**COMMITTEE OF THE WHOLE AUGUST 31, 2010**

**SITE DEVELOPMENT FILE DA.10.046  
FABIO ALVIANI, GIOSEFFINA GRECO  
ALVIANI & ANDREA GRECO  
WARD 1**

Site Plan As Red-Lined on August 31, 2010

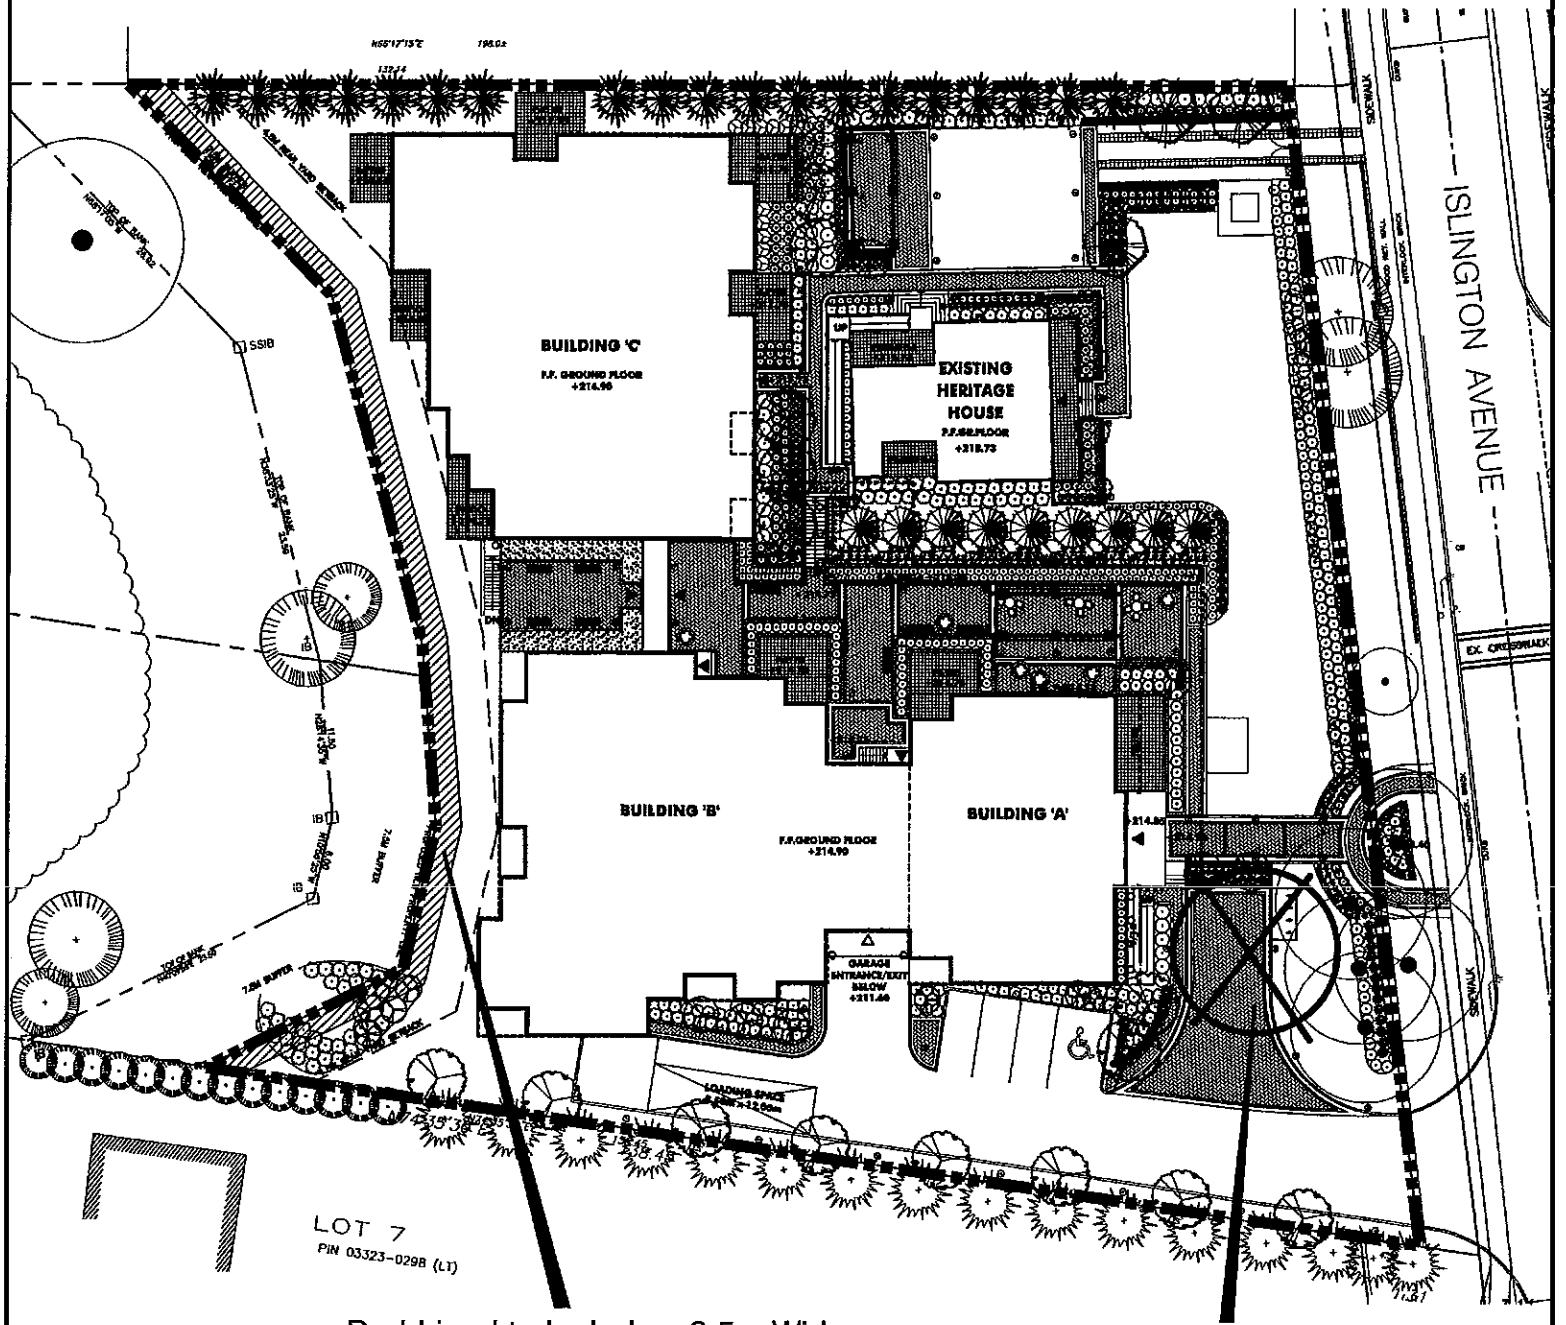
- a) the proposed Site Plan and Landscape Plan be amended as shown on Attachments #3 and #4 to reflect the following:
    - i) delete the proposed 6.0 m wide aisle located between Islington Avenue and Building "A"; this area shall be landscaped accordingly to comply with the Ontario Municipal Board (OMB) approved Zoning By-law 266-2009; and,

- ii) label the required 2.5 metre wide landscape buffer area adjacent to the westerly property line, to be used for no other purpose than soft landscaping, as identified in the OMB approved Zoning By-law 266-2009.

Red-Lined to Include a 2.5m Wide Landscape Buffer Area

To Be Removed and Replaced with Landscaping as per OMB Approved Zoning By-Law 266-2009

*Landscape Plan As Red-Lined on August 31, 2010*

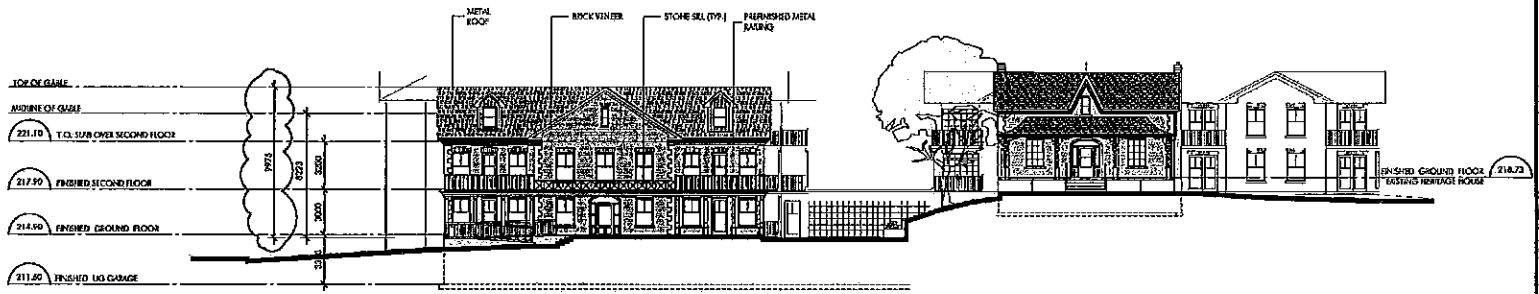
The landscape plan shown on Attachment #4 consists of a mix of coniferous and deciduous trees, ground plantings, and hard landscaping amenity areas. The Landscape Plan has been red-lined to remove the 6.0m aisle proposed at the southeast end of the site, as this is not consistent with Zoning By-law 188-2009 approved by the Municipal Board. The Development Planning Department is of the opinion that this is not a minor revision, and the site plan and landscape plans shall be red-lined to address this issue.

Red-Lined to Include a 2.5m Wide Landscape Buffer Area to be used for no other purpose than Landscaping as per OMB Approved Zoning By-Law 266-2009

To Be Removed and Replaced with Landscaping as per OMB Approved Zoning By-Law 266-2009
